SUMMIT HOMES - STONEY C 1921 SW MERRYMAN DR LEE'S SUMMIT, MO TODD W MOORE

ROOF

TRUSS LAYOUT

EVERSTEAD	П	
VINGS/SUBMITTAL REVIEW	П	
	П	
	П	
REVIEWED FOR DESIGN CONFORMITY	П	
L CONFORMANCE TO CONTRACT	П	9
Y. THE CONTRACTOR IS RESPONSIBLE	П	i
S AND CORRELATING DIMENSIONS AT	П	ì
LERANCE, CLEARANCE, QUANTITIES,	П	
OORDINATION OF HIS OR HER WORK	П	
ADES, AND FULL COMPLIANCE WITH	lt	
INTRACT DOCUMENTS.	П	
1.20	П	
STATUS:	П	
SIMIUS.	П	ż

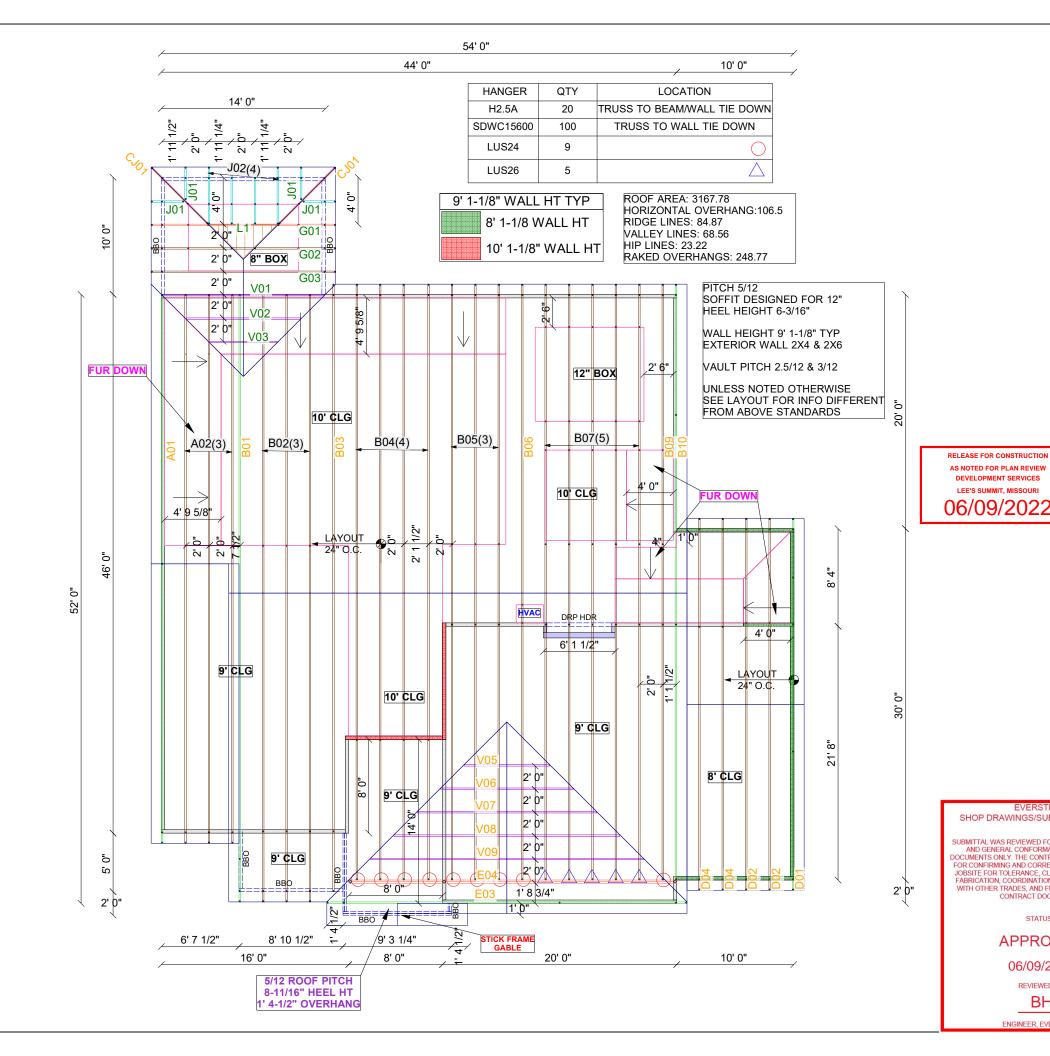
APPROVED

REVIEWED BY: BH
